## Kinneil House - Garden Retaining Wall

### Addendum to Engineer's Report dated 29 April 2016

Figure 1 – Location of trial pits

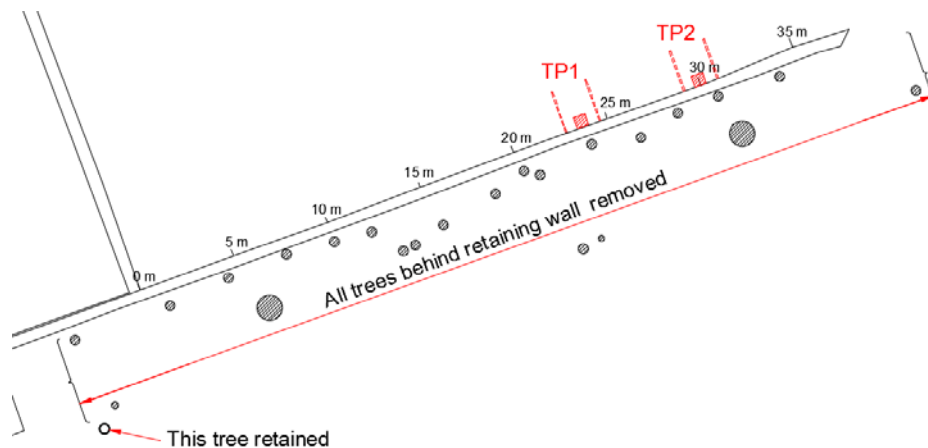
- 2.0 Since the initial report, the Leylandii and other trees on the upper side of the wall have been remove and two trial pits have been dug to determine the nature of the ground, and the nature and depth of the foundation. See figure 1.

3. The trial pits revealed:
  - (i) that wall has substantially no foundation – it is built directly off re-deposited clay flecked with charcoal, 520 to 600 mm below the existing ground level on the bottom side of the wall. The base stones are recessed back from the main wall by 50 - 60 mm; and
  - (ii) the outward incline of the wall extends down to the bottom of the wall below ground level.

5. It is the recommendation that the whole length of the wall should be taken down and rebuilt with a more substantial foundation. Stainless steel joint reinforcement should be provided along the length of the wall to provide some additional lateral strength.
